Addendum No. 1 **February 14, 2017**

Project: **Lansing Pathway Promise**
Project: SB-0006
Fairview Additions and Renovations

ADDENDUM #1

Project No.:	16-0400	**Date:**	February 14, 2017
Project:	Lansing Pathway Promise SB-0006 Fairview Additions and Renovations Ingham County, Michigan	**A/E Firm:** **Project Manager:**	C2AE Steve Jurczuk
Owner:	Lansing School District 519 West Kalamazoo Street Lansing, MI 48933

FIRST FLOOR LIFE SAFETY PLAN
1" = 20'-0"

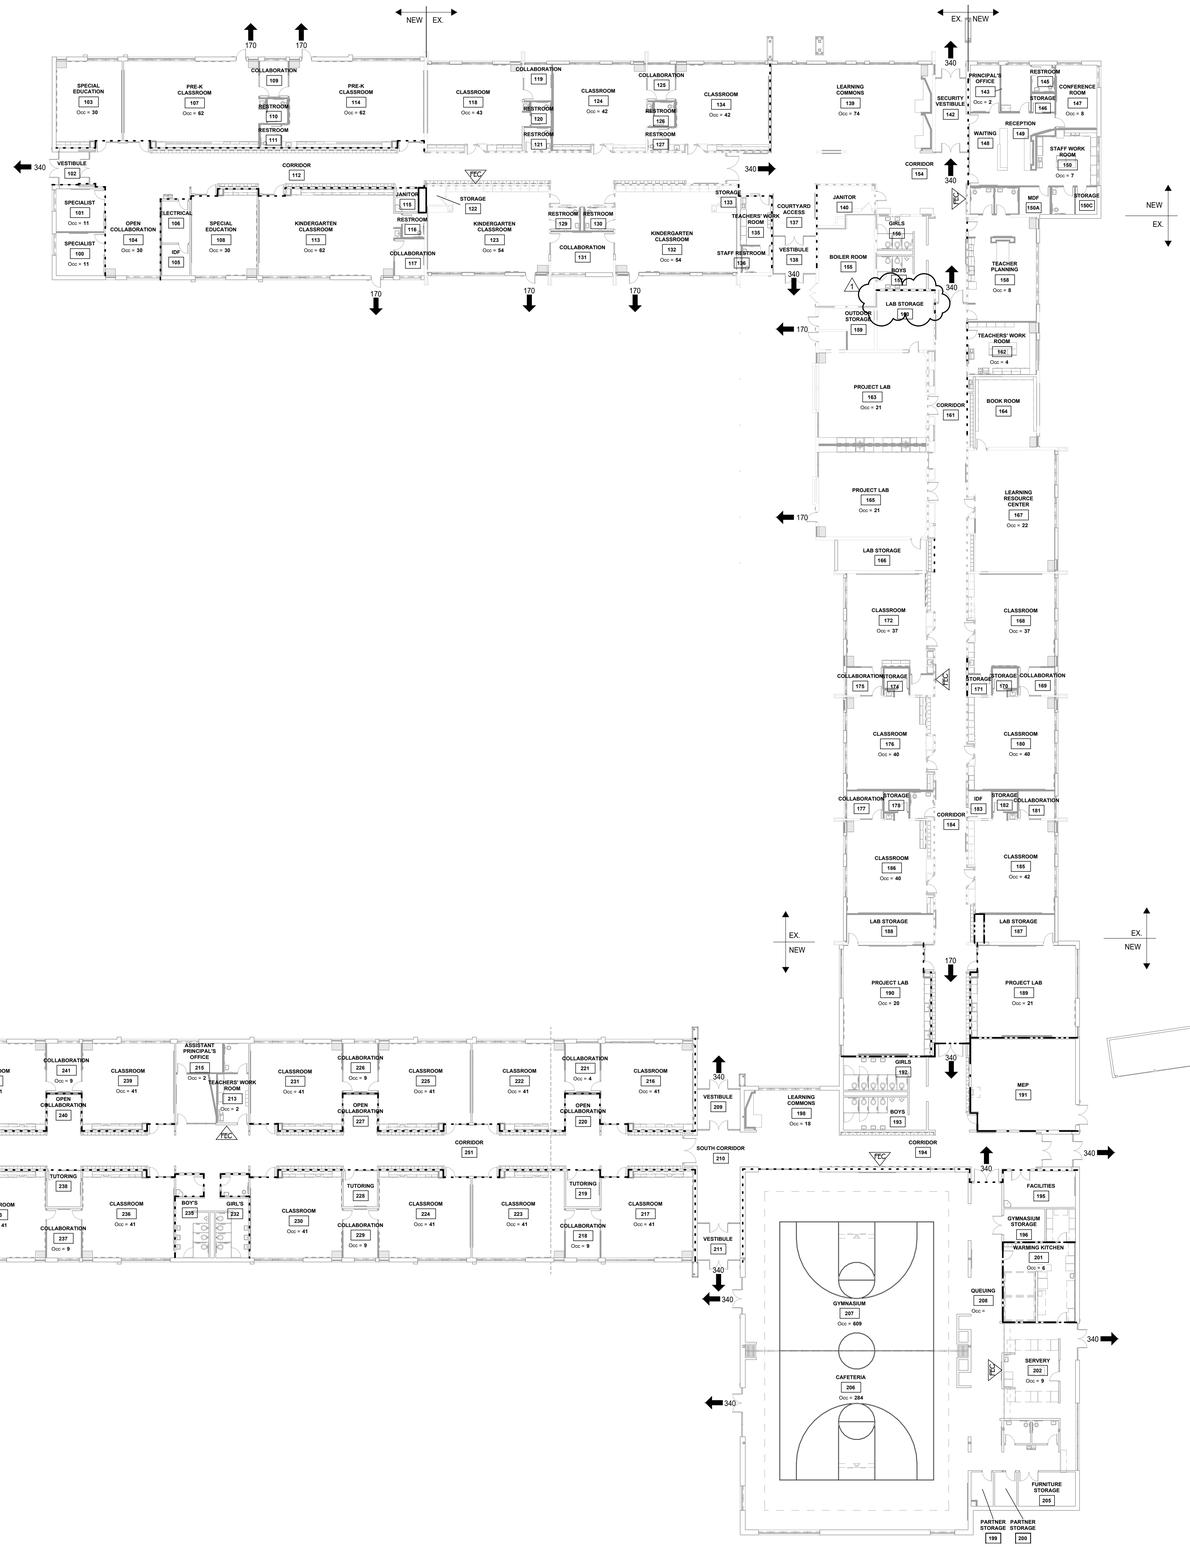
A1.9 Refer to Sheet G-110 (reissued):
REVISE to construct two hour fire wall at location of two hour fire barrier.

SCALE: As indicated
PROJ. #: 160400
DATE: 01/13/2017
SHEET: G-500
Addendum #1

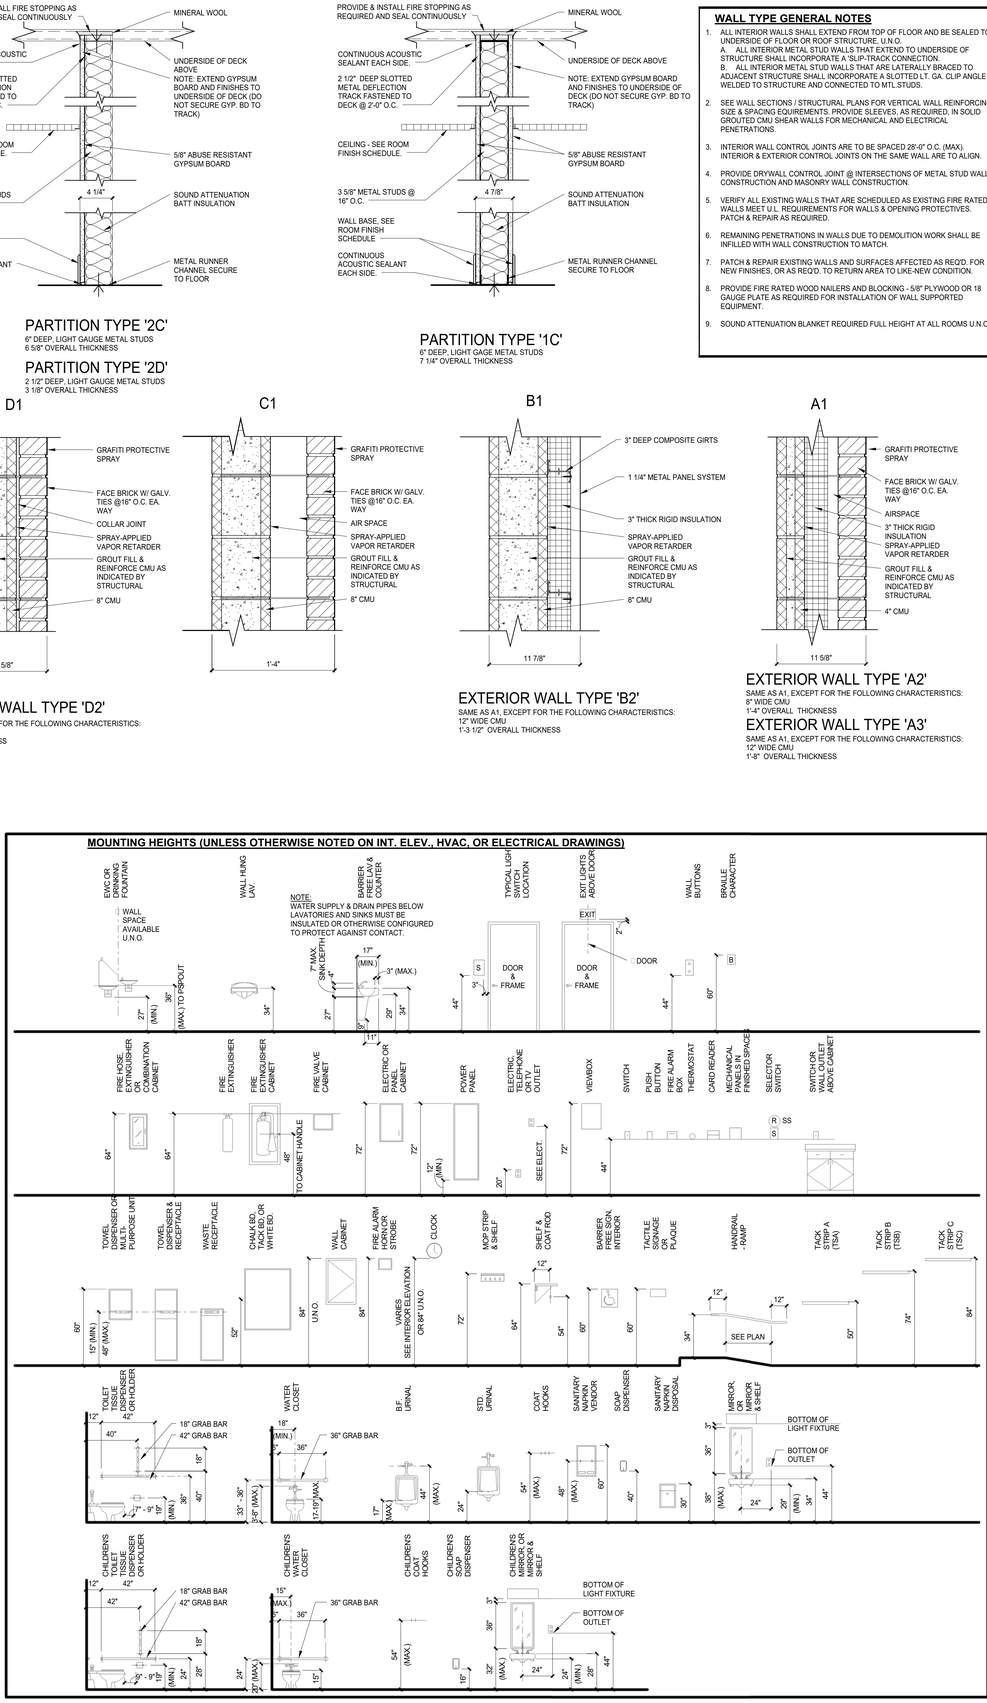
A1.10 Refer to Sheet G-500 (reissued):
REVISE wall types as shown.

FIRST FLOOR DEMOLITION PLAN
3/32" = 1'-0"

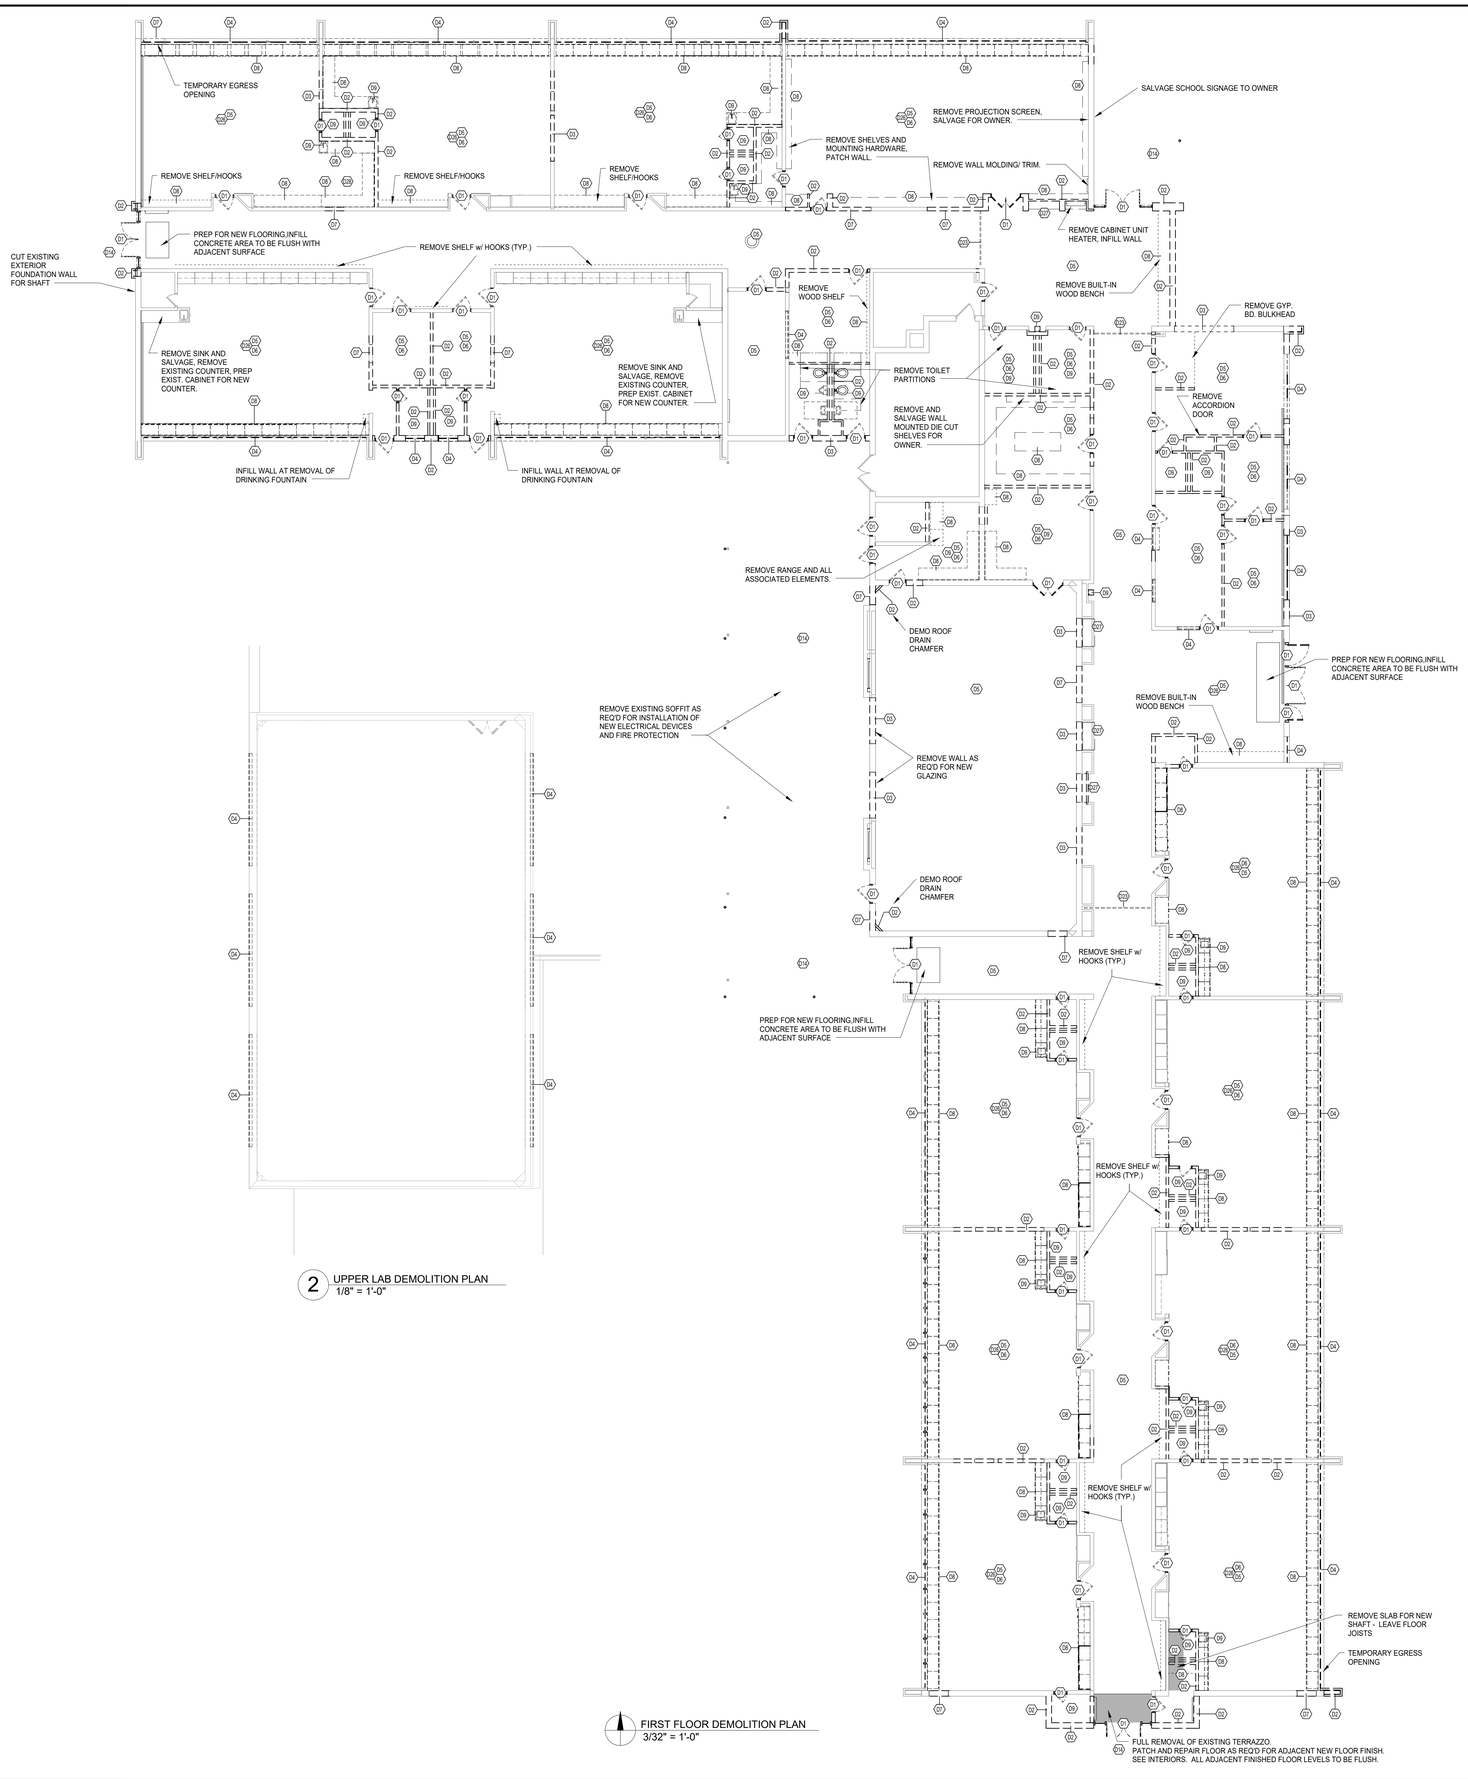
A1.18 Refer to Sheets AD-110, A-110C, A-111C and I-206 (reissued):
REMOVE additional built in casework in room 167. Construct new wall and adjust ceiling as shown.

ROOF DEMOLITION PLAN
3/32" = 1'-0"

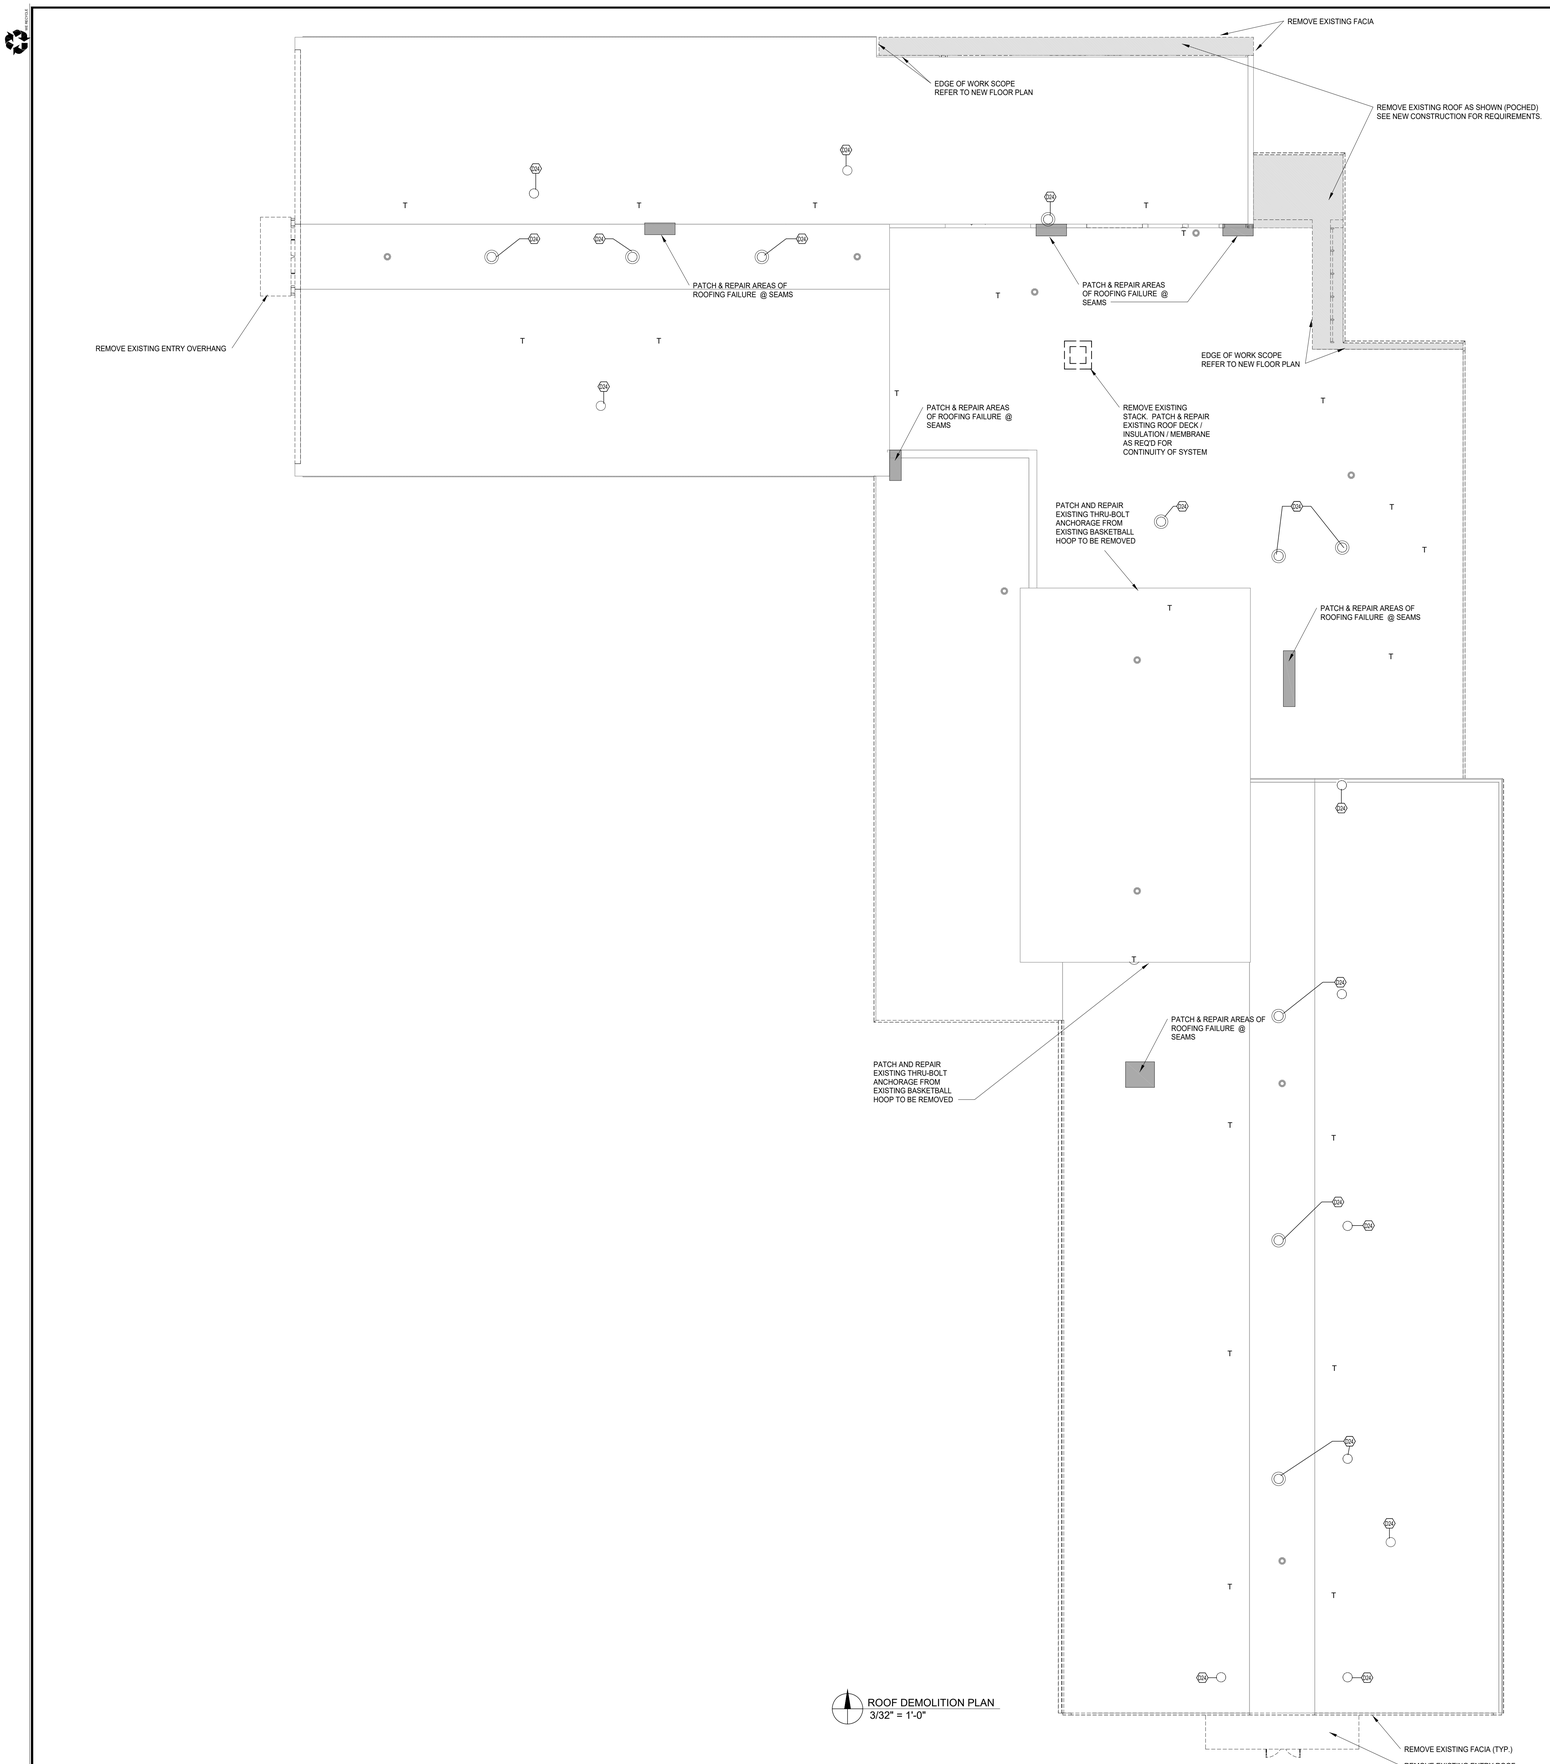
A1.19 Refer to AD-120 (reissued):
Clarify extents of roof demolition and patching.
